S.S. PAPADOPULOS & ASSOCIATES, INC.
ENVIRONMENTAL & WATER-RESOURCE CONSULTANTS

February 12, 2009

Subject: **Response to EPA/NMED comments on Sparton Technology, Inc., Former Coors Road Plant Remedial Program, 2003-2007 Annual Reports**

ATTACHMENT 1

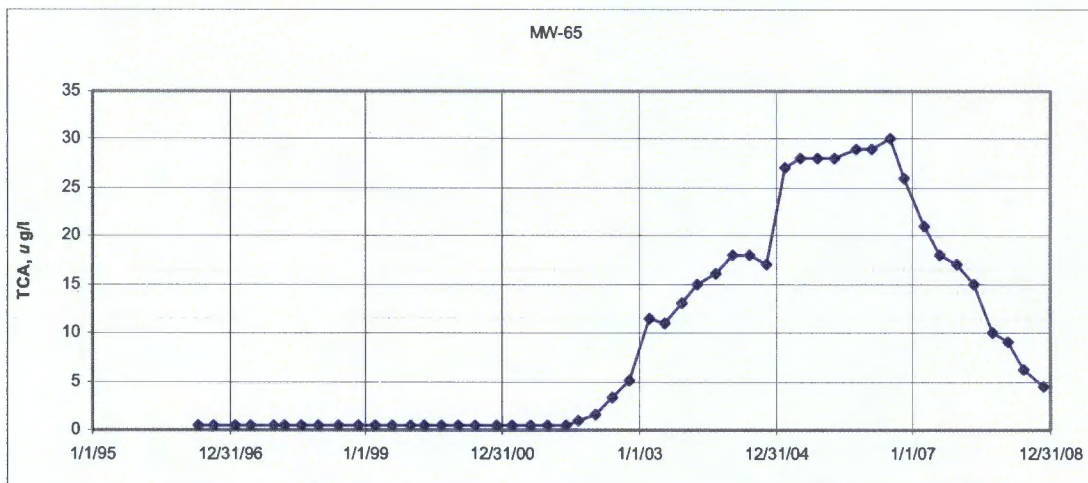
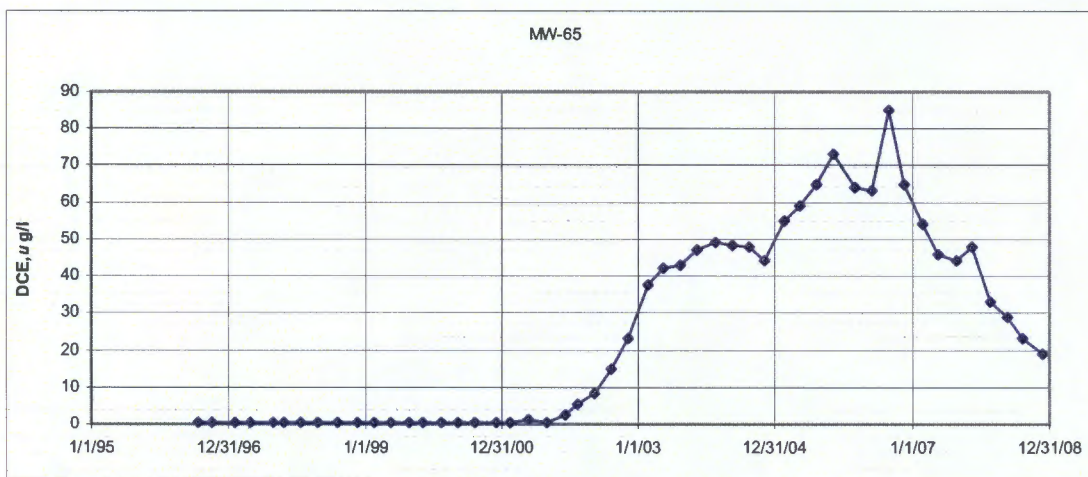
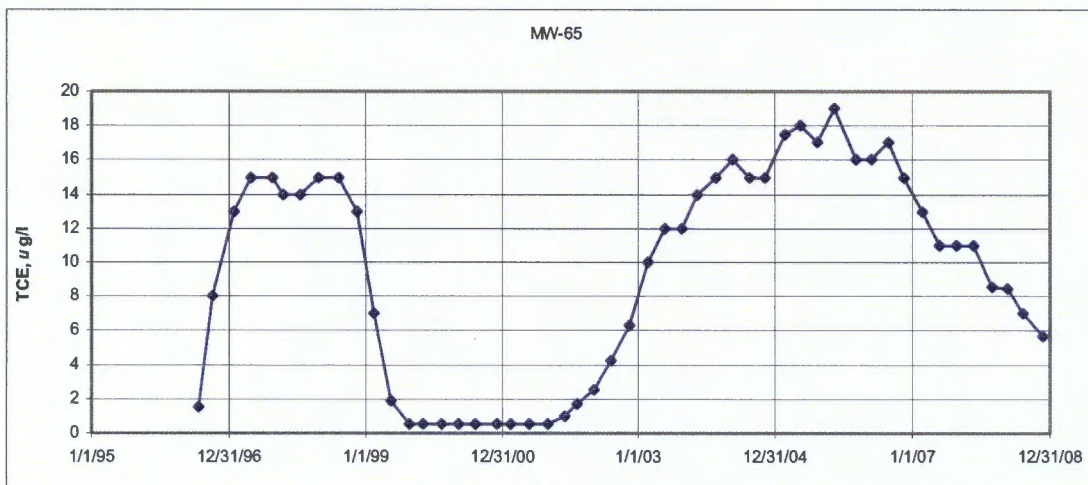
Section 2.6.1.4, Dissolved Contaminant Mass, and Section 6.2.2: The initial estimate of 2178 kg of dissolved TCE in the plume has needed to be adjusted up to the current 6,881 kg to account for plume remediation results thus far. Relevant to this, we note that high TCE concentrations have persisted in well MW-60. MW-60 had 11,000 µg/L TCE in November 1999. This is 1% of TCE's water solubility of 1,100 mg/L. The well's water reached 18,000 µg/L TCE in 2004. Empirical evidence has shown that groundwater containing a NAPL (non-aqueous-phase liquid) contaminant at 1-2% of its solubility indicates a nearby NAPL source. Since MW-60 is about 1/3 mile off site, we might reach the conclusion that NAPL has traveled from the site, and downstrata, to an area near MW-60; this would bode for a very long remediation period. Alternatively, this might conceivably be a fairly cohesive slug of highly contaminated groundwater with no associated NAPL; only time will tell, when and if this slug passes. This report needs to address this potential for offsite NAPL, effects of such NAPL, and ways in which the remedial system and modeling may need to be altered if this NAPL is present.

The changes in TCE concentration at CW-1 since production began indicate that areas with high concentrations of dissolved TCE, such as those observed in MW-60, have existed in the area between CW-1 and on-site production well CW-2. The breakthrough curve from well MW-60 (Attachment 1) indicates that the high concentrations of TCE observed in this well are consistent with two slugs of groundwater with high concentration of dissolved TCE, one of which peaked in November 1999 and the second one in November 2004.¹ The presence of slugs of highly contaminated water that have migrated from the site is consistent with the dissolved TCE concentrations above 10,000 µg/L and as high as 73,000 µg/L observed in samples from several on-site UFZ wells in the mid 1980s. There is no plausible physical mechanism by which TCE NAPL could migrate horizontally for a distance of over 2,000 feet from the site within a shallow horizon of a thick and fairly homogeneous aquifer. NAPL has never been observed in any on-site boring or in any on-site monitoring well samples. This discussion will be expanded in the 2008 Annual Report, but since there are no current NAPL sources, Sparton sees no need to discuss the effects of such a NAPL source or the "ways in which the remedial system and model may need to be altered if this NAPL is present."

¹ See discussion on first paragraph of page 5-4 of 2007 Annual Report. Also note that, as shown in Attachment 1, the TCE concentration in the well continued to decline during 2008 from 5,700 µg/L in November 2007 to 4,800 µg/L in November 2008.

ATTACHMENT 2

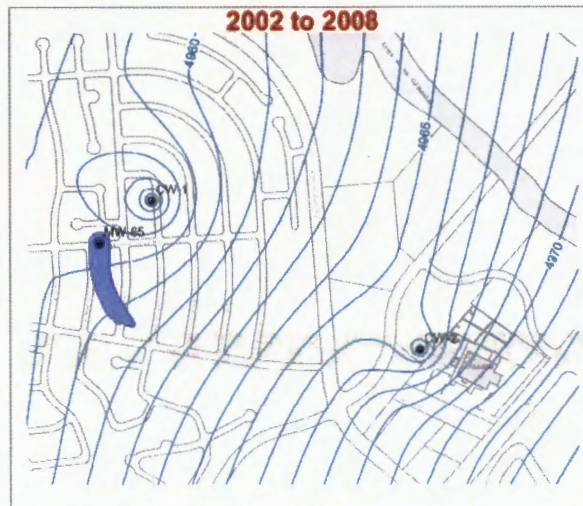
Figures 2.14 & 5.3: The toe of the plume has only one remaining sentinel well location, at wells MW-68/69, even though the plume is generally about 1600' wide. This one location is not downgradient of the furthest-downgradient contaminated wells, MW-65 and OB-2, so there is inadequate data to verify that the plume extent is defined or that the plume has been fully contained. MW-65 was originally a sentinel well, but is now contaminated, so it should be replaced with another sentinel well in a downgradient location. There is currently not enough information to know whether the plume is wholly within the capture zone of well CW-1 or whether some contaminants of concern (COCs) are escaping capture by well CW-1 (as illustrated in Figures 5.2, 5.10, 5.11, 5.15, 6.4, 6.5, and 6.6 in the 2006 report; in Figures 5.11, 5.15, 6.4, 6.5, and 6.6 in the 2007 report). Any unmapped contaminants much beyond MW-65 or OB-2 may have escaped containment and continued flow downgradient. Therefore, one or more wells or well clusters need to be emplaced west-to-northwest of MW-65 and OB-2, preferably just outside of the calculated capture zone to verify plume capture. Sparton shall submit a work plan for siting and installation of this well or these wells.

Fig. 2.15 & 5.16, DCE Plume maps: Well MW-65 became clean soon after well CW-1 extraction operations began, but then became re-contaminated two years later. This new contamination has predominant DCE and significant TCA, in about the same proportions as in well MW-62 but quite different from the main plume. We believe that another, related, plume runs from the source area (the Sparton facility site) through MW-62 to MW-65, where it is at least partially drawn to well CW-1. The maps and model should be adjusted according to this scenario. Consider whether more wells are needed to characterize this plume area.

Second, well MW-65 was not a sentinel well at the time of the Consent Decree; it had 13 $\mu\text{g/L}$ of TCE in November 1998; the November 2007 TCE concentration in the well was lower, 11 $\mu\text{g/L}$, and it declined further in 2008 to 5.7 $\mu\text{g/L}$ in November (see Attachment 2); the breakthrough curves shown in Attachment 2 indicate that contaminants in this well may soon be at levels below detection limits. Note also that well OB-2 is not on the Monitoring Plan (Attachment A of the Consent Decree) and that it has not been sampled since September 1998. As shown in Figure 5.15, groundwater that was near and beyond OB-2 at that time was already pumped out by CW-1 within the first two years of operation.

Sparton agrees that the contaminants detected in well MW-62, and in well MW-65 since 2001, are due to a different plume than the main plume. In fact, it appears that the contaminants detected in well MW-52R also belong to this separate plume. The TCE concentration history of MW-65 (see Attachment 2) indicates that the TCE that was present in this well prior to the start of pumping from CW-1, and which was most likely associated with the main plume, cleaned up soon after the beginning of the off-site system operation. The TCE that appeared in this well in 2001, at the same time as the DCE and TCA, is clearly associated with a separate plume.
